Visual evidence for the Archway Campus tower

The applicant's visual evidence for P2024/2598/FUL consistently understates how visible and dominant the 27-storey, 82m tower would be. The applicant states that Landscape Institute Technical Guidance Note 06/19 (TGN 06/19) have been followed. This is open to question in a number of respects.

The Joint Action Group (JAG) have prepared seven comparison pairs that set the applicant's images beside JAG photographs taken at or near the same positions. In each, the tower has been added as an illustrative montage and its size cross-checked against the applicant's own model.

View 45: Archway Bridge (new view)

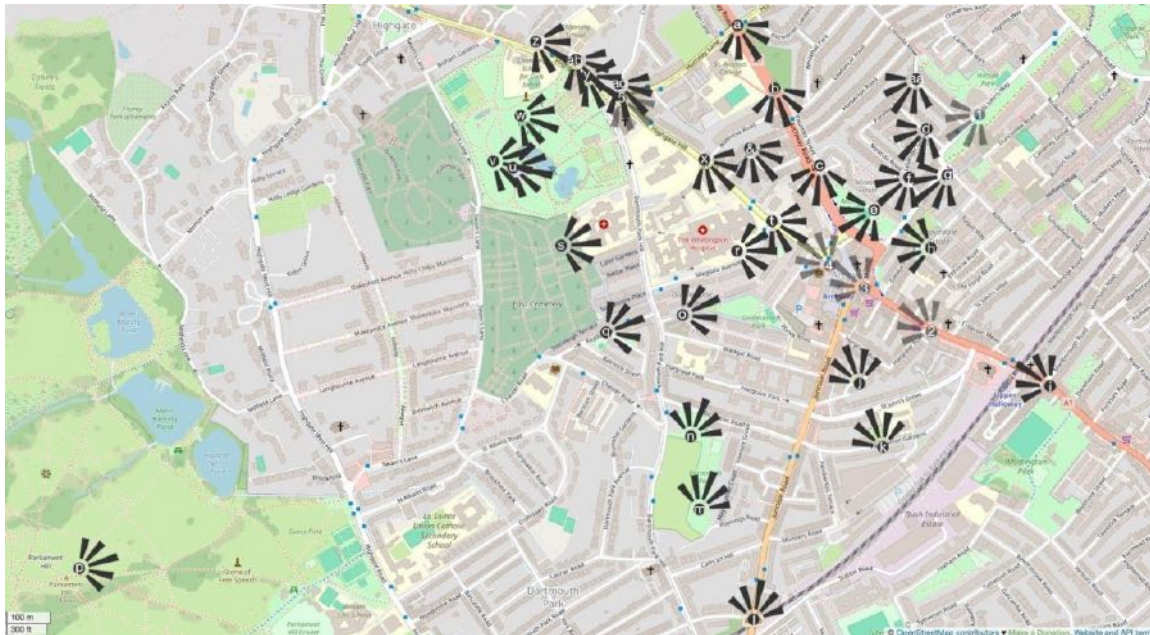
Applicant View 45 (Archway Bridge, Heritage Statement Addendum), 24mm, winter; this updates the applicant's earlier View 10b, taken from close to the same position. Comparison photograph (Overleaf - recreated Oct 2026) with the camera positioned nearby between the bridge rails, 16 February 2023, iPhone 14 Pro, 77mm equivalent. This is listed as Protected View LV5 in the 2023 Islington Local Plan (Archway Bridge to St Paul's Cathedral). Montage illustrative, not survey-verified. Tower width and face proportions cross-checked against the applicant's View 45 render; width within $\pm 5\%$, height within $+10\%$. Confidence: high.
